# City of Columbia

Council Meeting Date: April 18, 2016

Re: Adoption of the 2015 International Code Council Family of Codes, with Amendments

Council Bill No. B 107-16

Section R403.1.6 Foundation Anchorage

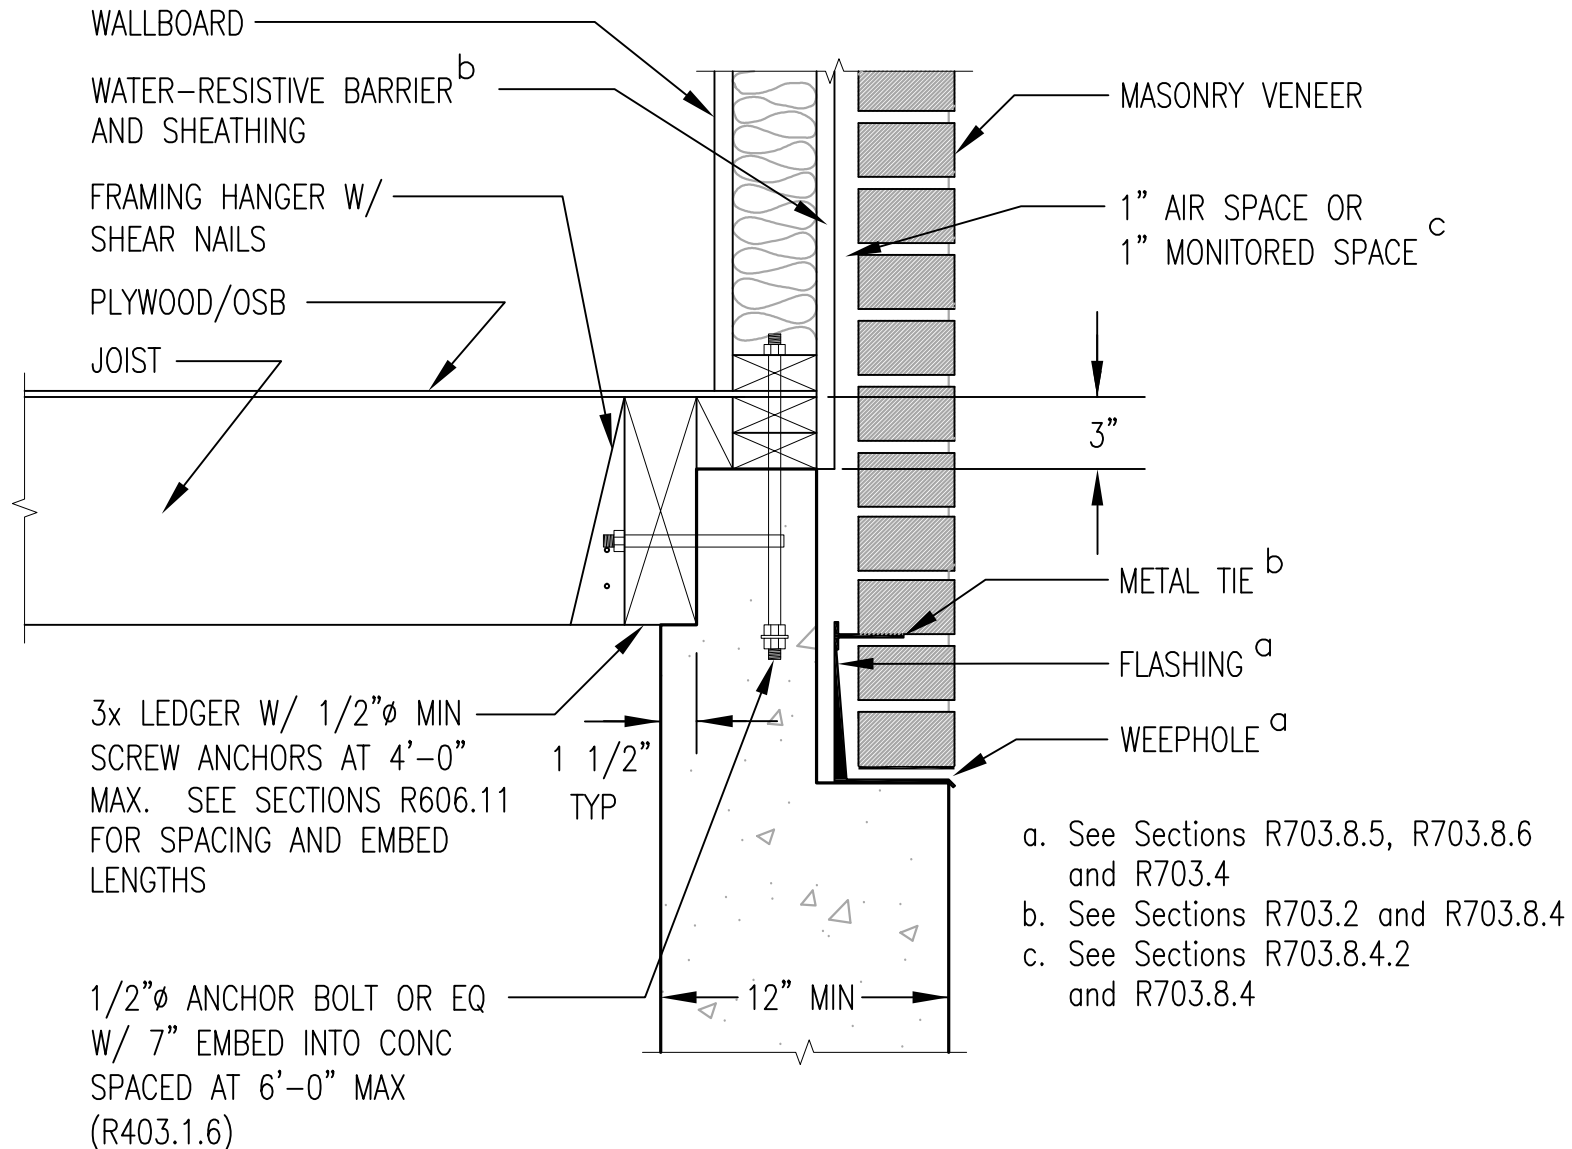
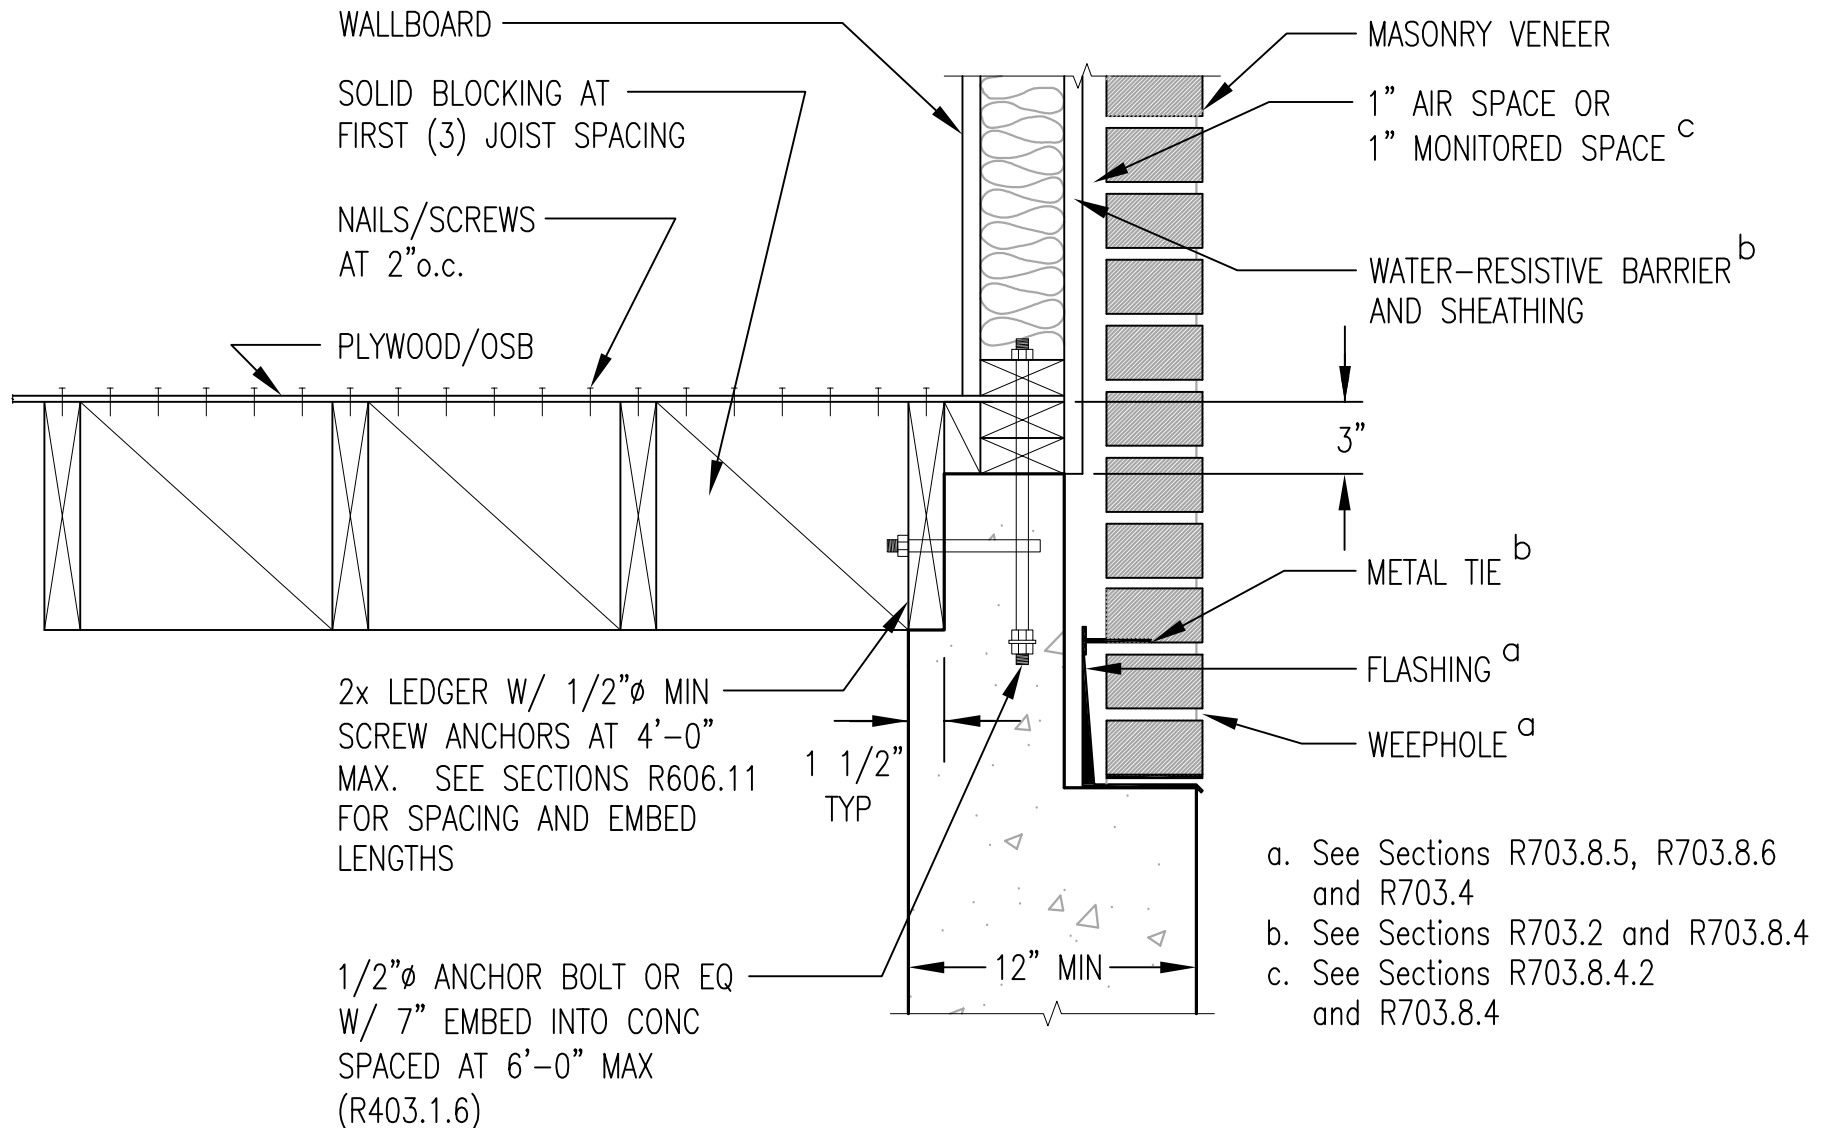
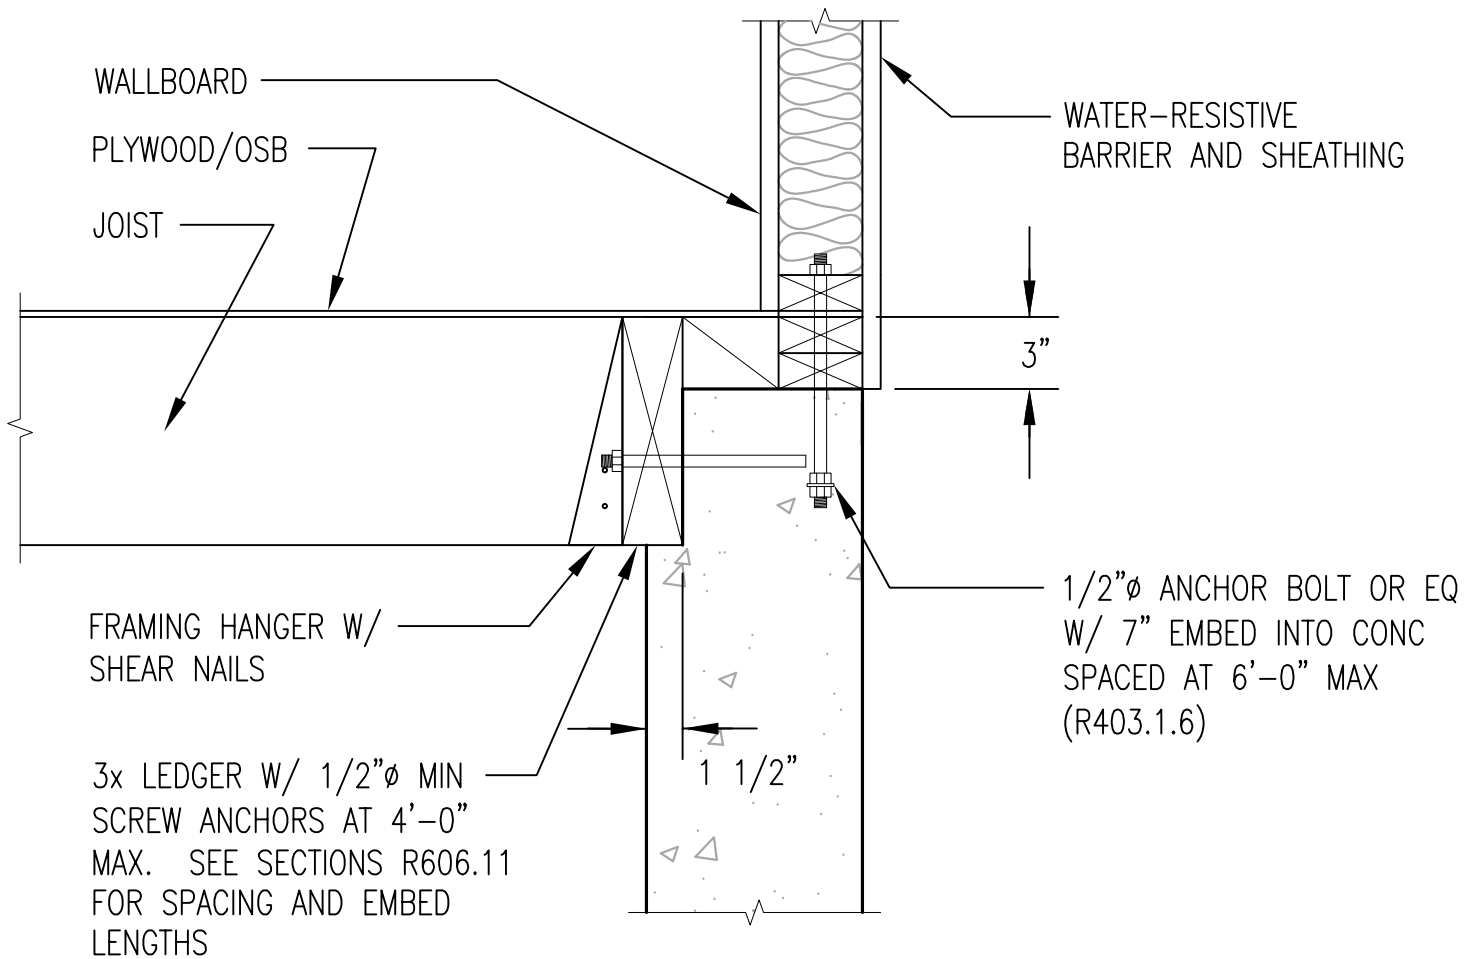
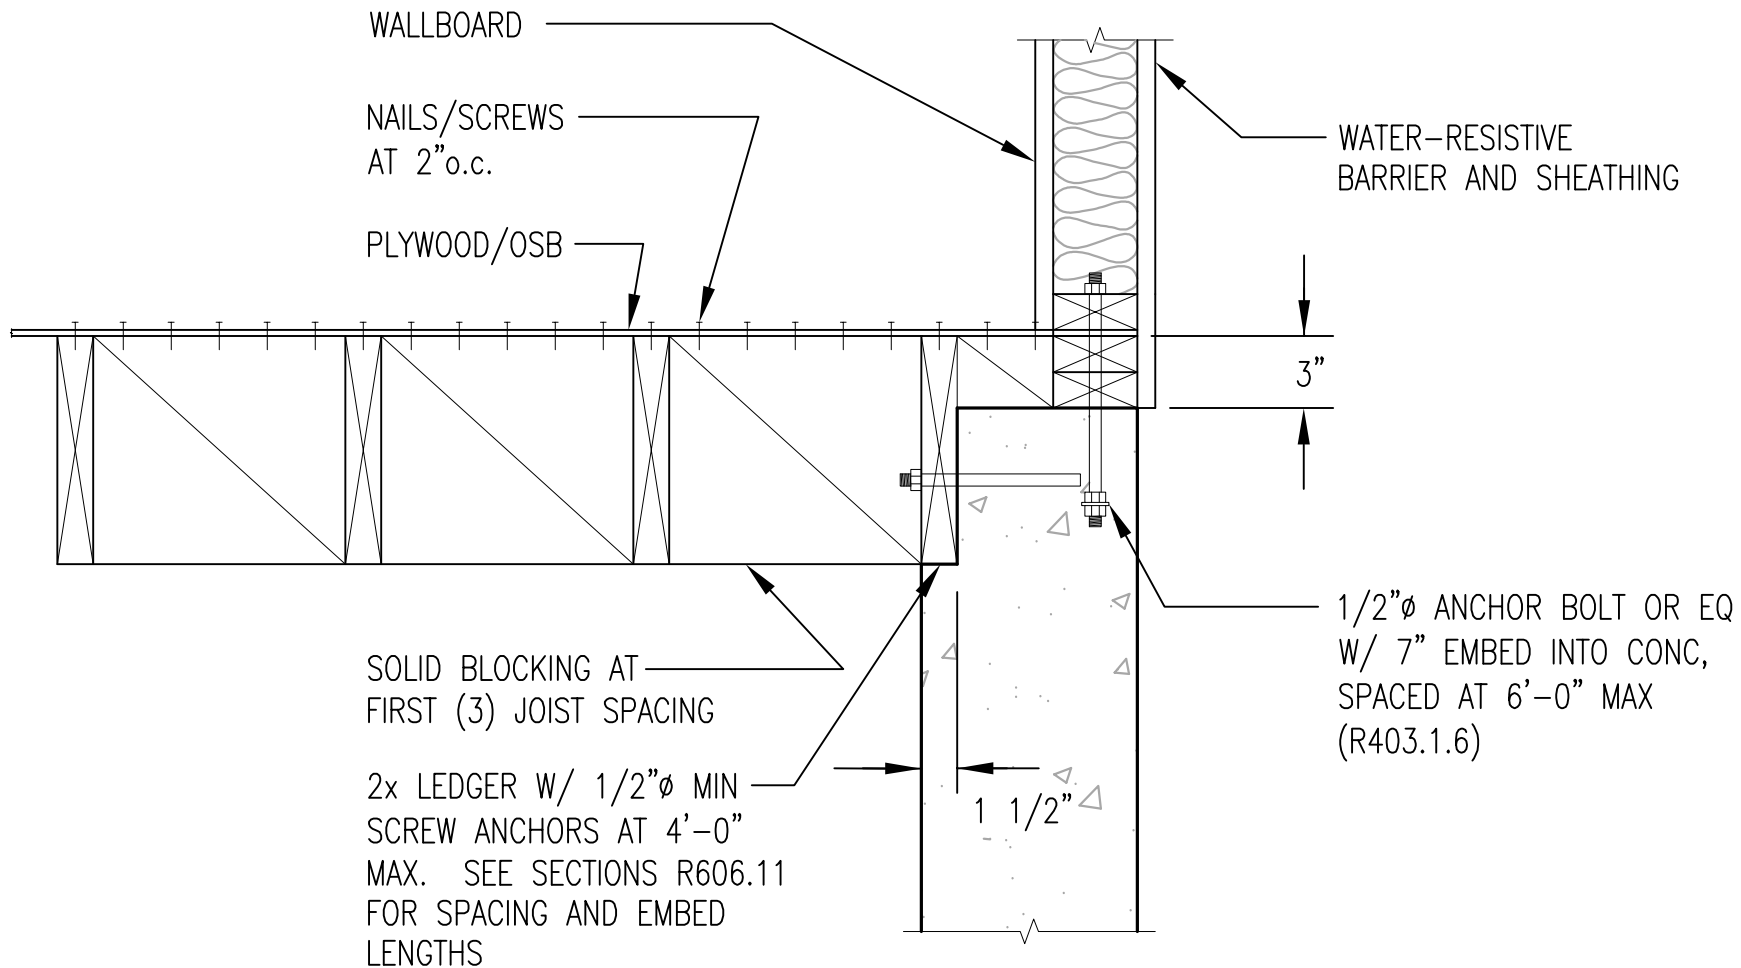
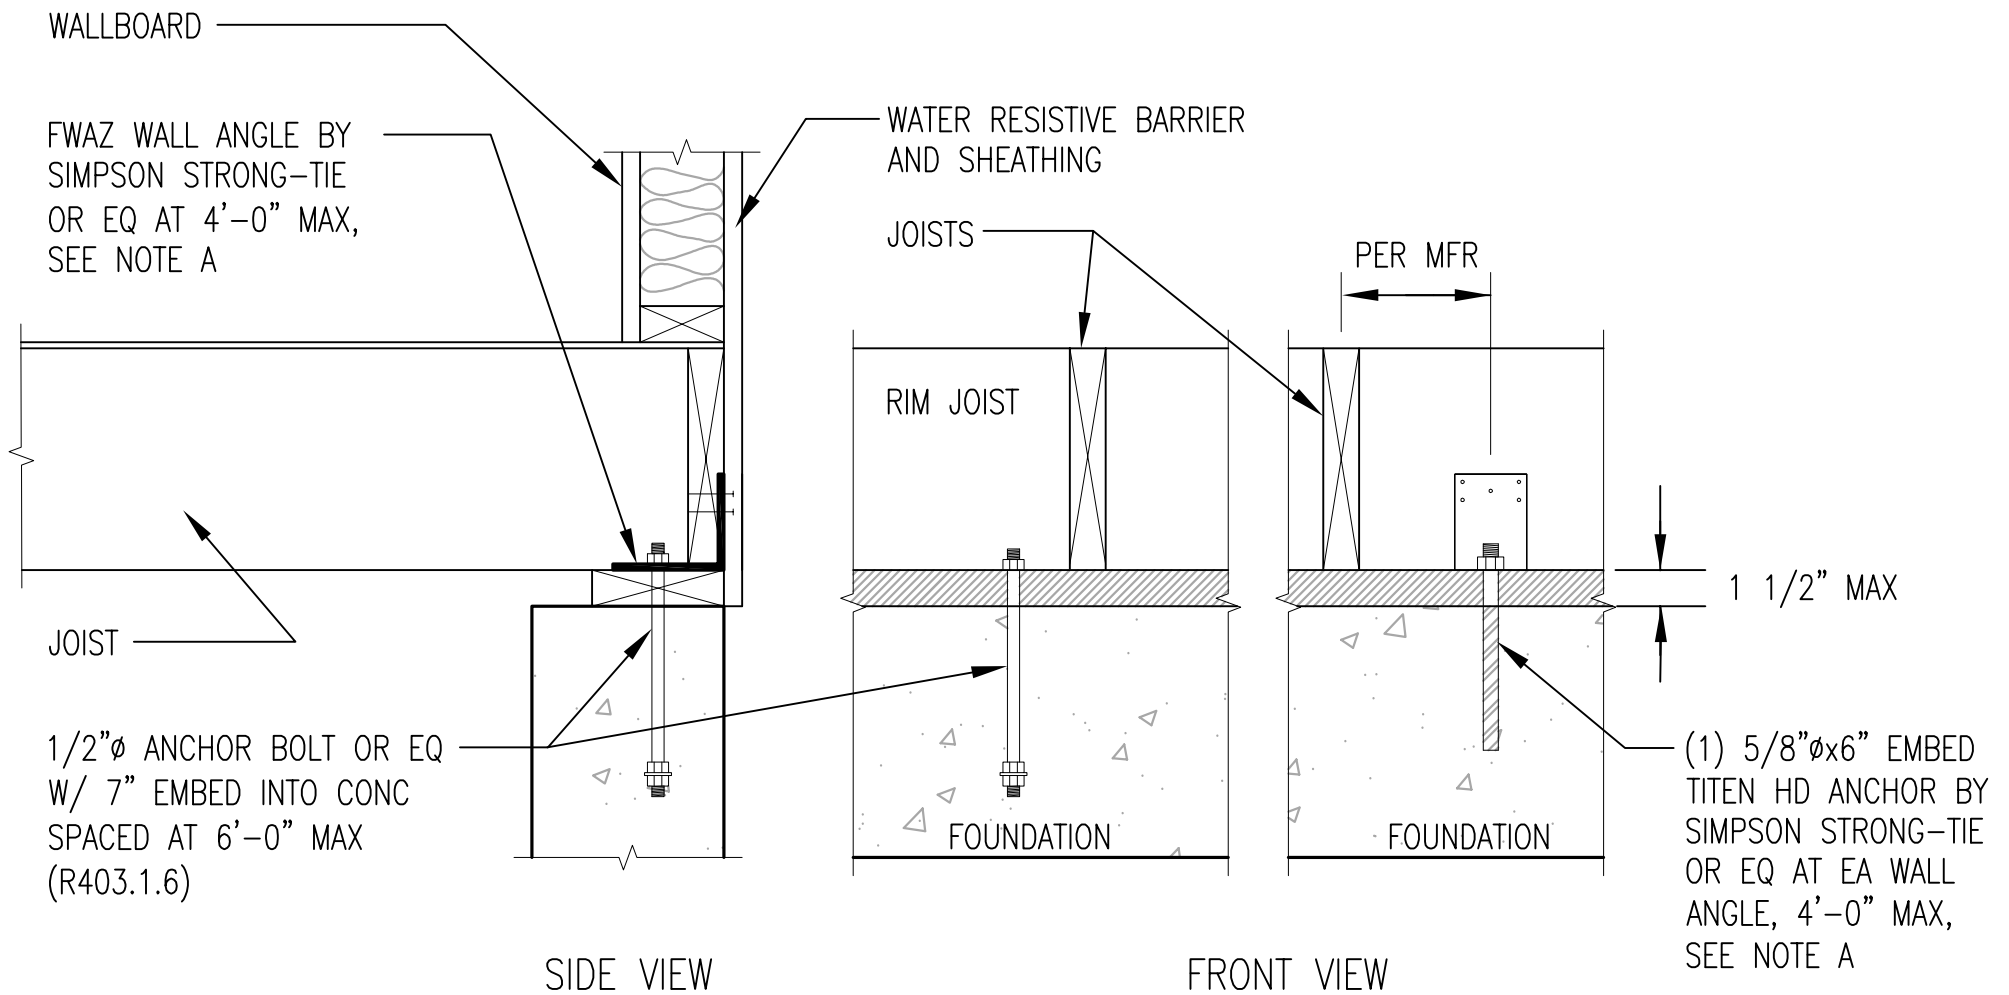
*R403.1.6 Foundation anchorage.* Add the following to the end of the section, prior to the Exceptions: The connection of the foundation walls to floors shall be per the alternatives labeled 1.1, 1.2, 1.3, 1.4, 2.1, 2.1, 3.1, 3.2 or 4.
